Office Action Summary	Application No.	Applicant(s)
	09/986,995	KOELLE ET AL.
	Examiner Carlos Lugo	Art Unit 3676

DETAILED ACTION

1. This Office Action is in response to applicant's RCE filed on May 27, 2005.

Attachment #1

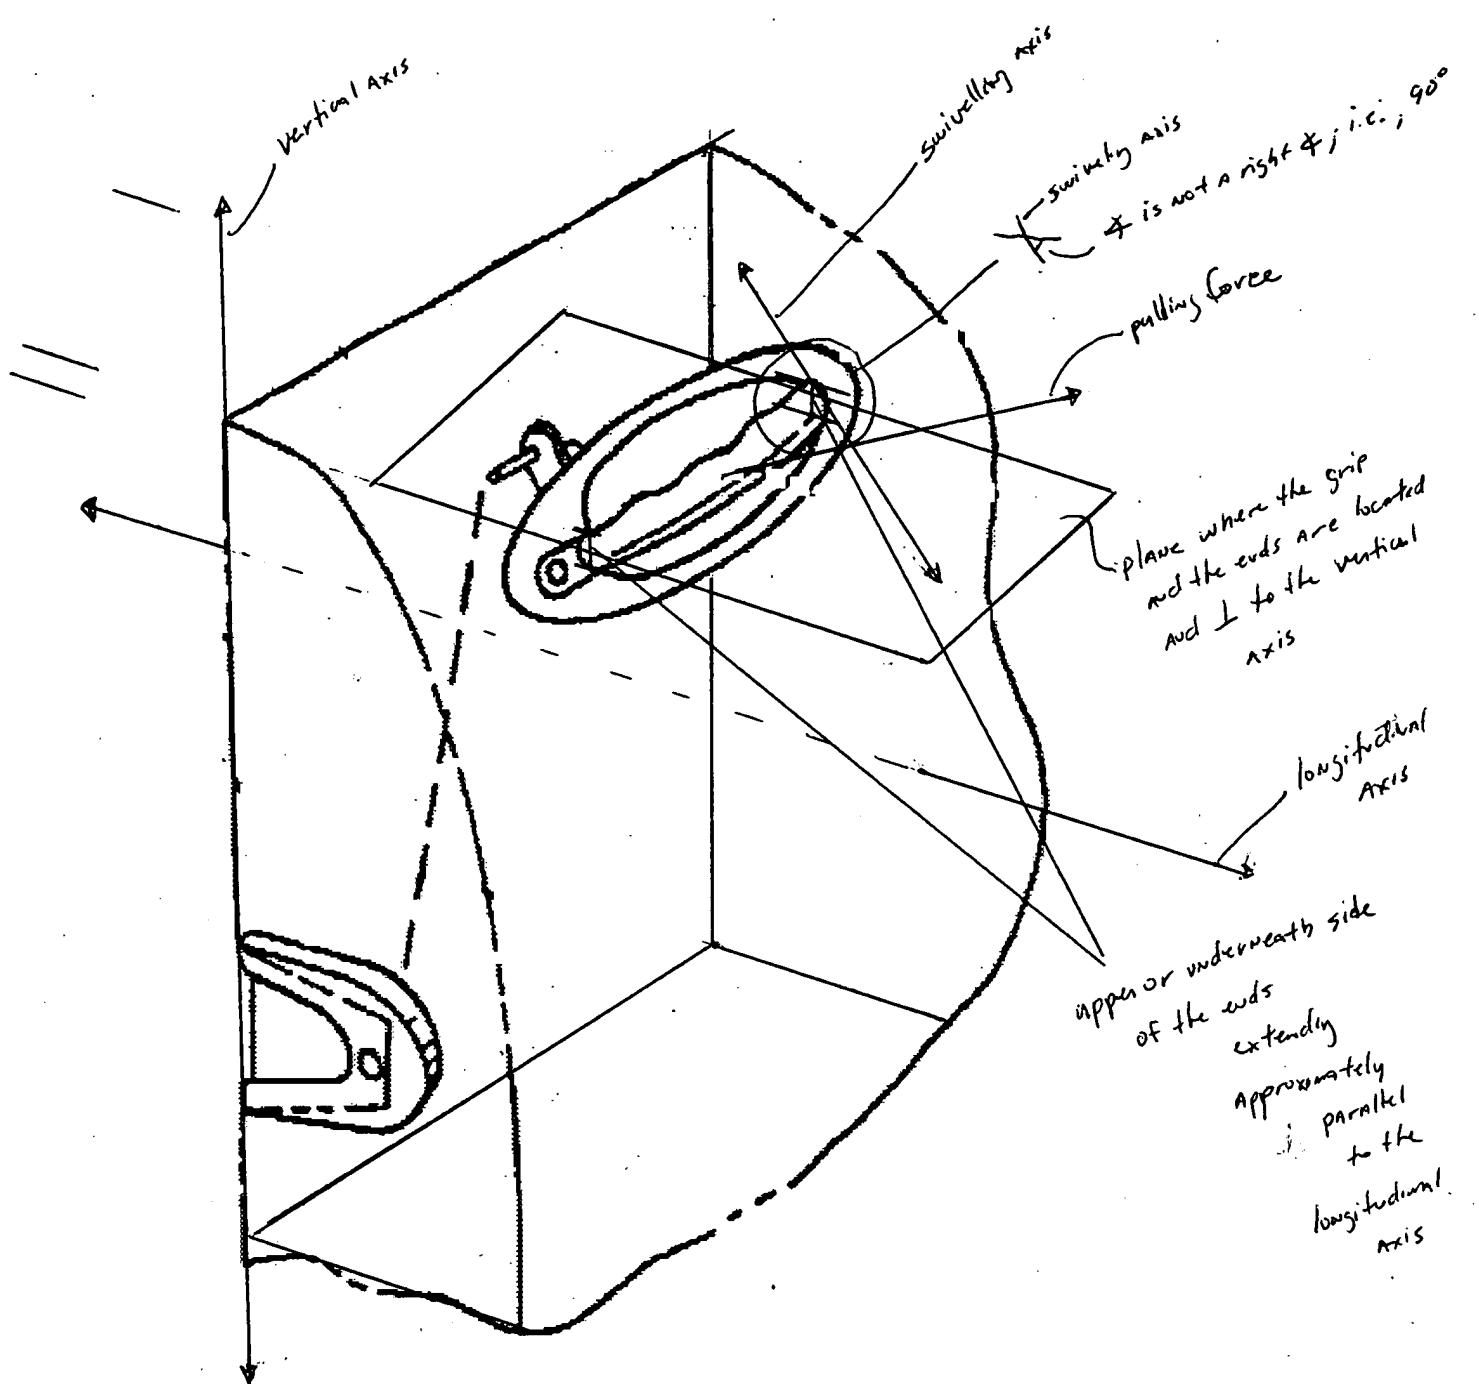
The mounting is designed such that the swiveling axis is tilted in a direction transverse to the longitudinal axis and away from the vertical axis, such that the handle pull pivots upward and outward when the door lock is opened (because of the inclination of the door handle arrangement with respect to the door, see attachment #1).

Also, Larabet discloses that at least in an area of the handle pull ends, an upper side or an underneath side of the handle pull extends approximately parallel to a horizontal plane of the vehicle, such that an angle between the swiveling axis and the upper or underneath side of the handle pull is a no right angle (see attachment #1).

Regarding applicant's arguments that Larabet fails to disclose that at least in an area of the handle pull ends, an upper side or an underneath side of the handle pull extends approximately parallel to a horizontal plane of the vehicle, such that an angle between the swiveling axis and the upper or underneath side of the handle pull is a no right angle (Page 6 Line 13), Larabet illustrates that limitation (see attachment #1).
